BID #2021-03
RETROFIT OF OREGON MANUFACTURING INNOVATION CENTER
RESEARCH AND DEVELOPMENT (OMIC R & D)
RESPONSE TO CLARIFYING QUESTIONS TWO
May 5, 2021

ELEVATOR RECALL DETAIL

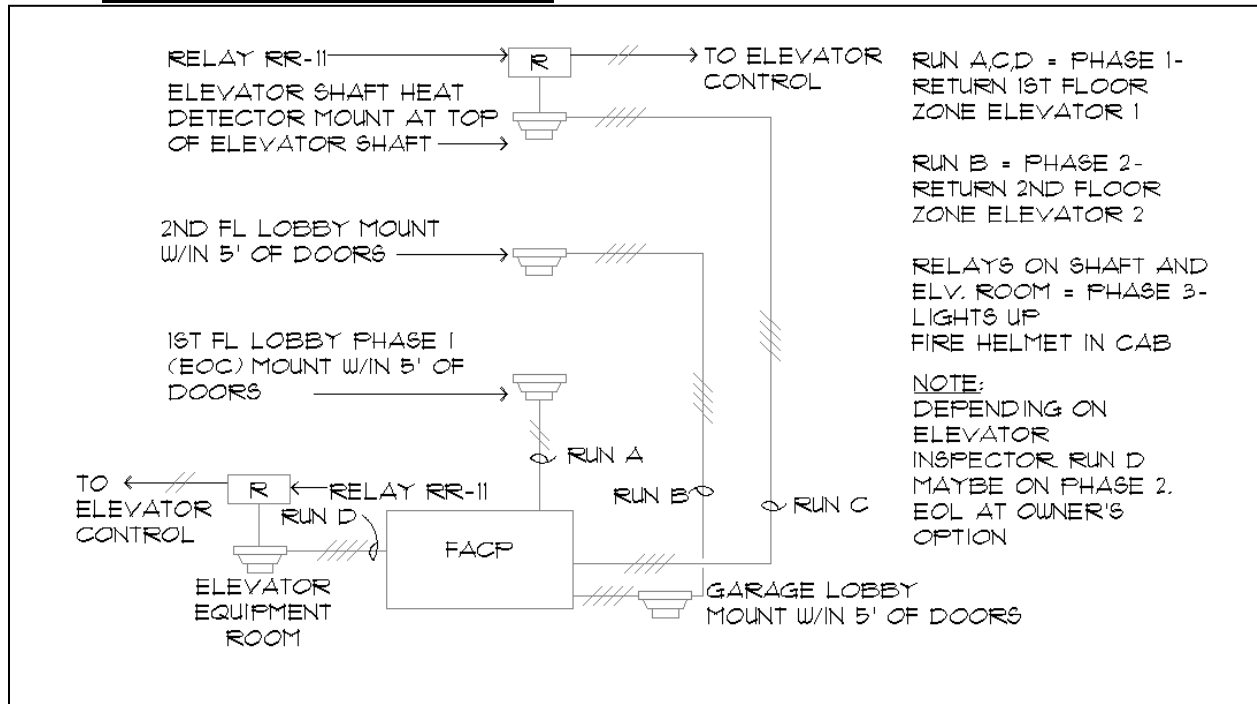
PROVIDE ELEVATOR RECALL SYSTEM FOR EAST ELEVATOR AS FOLLOWS:

ELEVATOR RECALL SYSTEM:

1. Provide packaged elevator recall system complete with battery backup, smoke and heat detection elevator control interface and shunt-trip capacity.
2. Provide proper fire hat illumination, flashing, and operation per OSSC.

3. Provide high water/oil in shaft alarm annunciated on remote panel.
4. Recall Master Panel: Conventional Type.
 - a. Example Model: Silent Knight SK-2
5. Remote Annunciator: Powered off control panel with LCD display and audible alarm.

- a. Example Model: Silent Knight 5230
6. Relay Interface: UL listed.
 - a. Example Model: System Sensor EOLR-1
7. Smoke Detector: UL Listed, powered from control panel, conventional type, photoelectric, white housing, LED alarm/heartbeat indicators.

- a. Example Manufacturer: System Sensor
8. Heat Detector: UL Listed, powered from control panel, conventional type, white housing.
 - a. Example Manufacturer: System Sensor

9. Submit Shop Drawings showing voltage drop, layout, model numbers, and battery calculations.
10. Connect Elevator Recall panel to existing fire sprinkler communicator

11. Connected Elevator Recall panel alarm output to existing fire alarm notification devices
12. See Detail herein for additional Requirements

DETECTOR/PANEL LOCATIONS:

- 1- Provide Heat and/or Smoke Detector at top of shaft as Required
- 2- Provide Heat and/or Smoke Detector at elevator pit as Required
- 3- Provide Smoke Detector over recall panel location
- 4- Locate Recall Panel outside of machine room, located per Arch.
- 5- Provide Smoke Detector at each elevator landing/stop
